# Access Compliance Report

## Public Rights-of-Way

### (Curb Ramps)

Intersection ID: 12527	Main Street: E_7TH_ST	Cross Street: N_DAVIDSON_ST	Location:	N
ADA ID: 97687FFAE05E	Ramp Type: PerpDiag	Initial Pass/Fail: Fail	Overall Compliance: No	Severity Score: 22.5

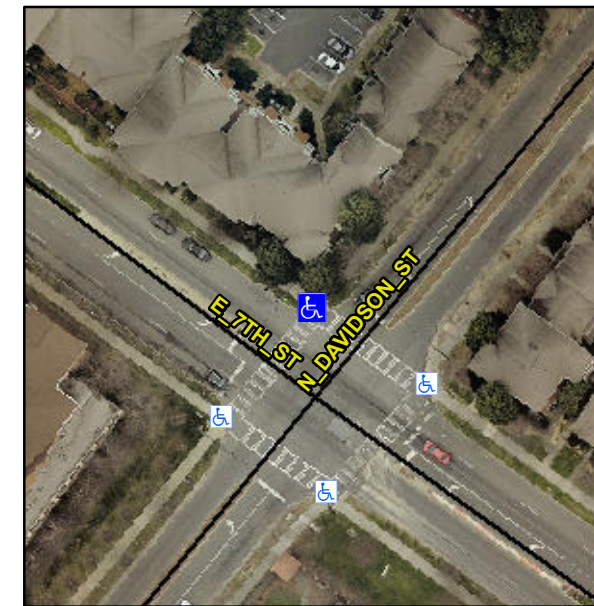
**R304.5.1, R304.2.2**

Compliance	Description	Data	Compliance	Description	Data
N/A	Ramp Length (in)	54.0	No	Ramp Slope (%)	8.4
No	Ramp Width (in)	37.5	Yes	Ramp XSlope (%)	3.8
N/A	Flare Type LT	N/A	N/A	Flare Type RT	N/A
N/A	Flare Slope LT (%)	N/A	N/A	Flare Slope RT (%)	N/A
N/A	Flare Traversable LT?	N/A	N/A	Flare Traversable RT?	N/A
N/A	Landing Length (in)	N/A	N/A	DWS Provided?	N/A
N/A	Landing Width (in)	N/A	N/A	DWS Contrast?	N/A
N/A	Landing Slope (%)	N/A	N/A	DWS Length (in)	N/A
N/A	Landing X Slope (%)	N/A	N/A	DWS Full Width?	N/A
N/A	Landing Curb? (Y/N)	N/A	N/A	DWS Offset (in)	N/A
N/A	Shared Landing?	N/A			
N/A	Gutter Ponding?	N/A	N/A	Gutter Slope (%)	N/A
N/A	Gutter Lip Ht (in)	N/A	N/A	Gutter X Slope (%)	N/A
N/A	Painted X Walk1?	Yes	N/A	Painted X Walk2?	Yes
	X Walk 1 Direction	To SW		X Walk 2 Direction	To SE
N/A	X Walk 1 Width (in)	111.5	N/A	X Walk 2 Width (in)	111.0
	X Walk 1 Slope (%)	3.9		X Walk 2 Slope (%)	3.8
	X Walk 1 X Slope (%)	3.2		X Walk 2 X Slope (%)	6.8

N/A	Ramp inside XWalk1?	Yes	N/A	Ramp inside XWalk2?	Yes
	Road Slope (%)	6.6	N/A	Clear Space?	N/A
	Road X Slope (%)	0.2	N/A	Clear Space to XWalk (in)	N/A
N/A	Any Obstructions?	N/A	N/A	Storm Grate/Utility Hazard?	N/A
	Obstruction Type			Storm Grate/Utility Type	
		N/A			N/A
		Yes		Surface Condition? (G/P)	Good

**Remove & Replace Curb Ramp With Two New Directional Ramps or Equivalent.**
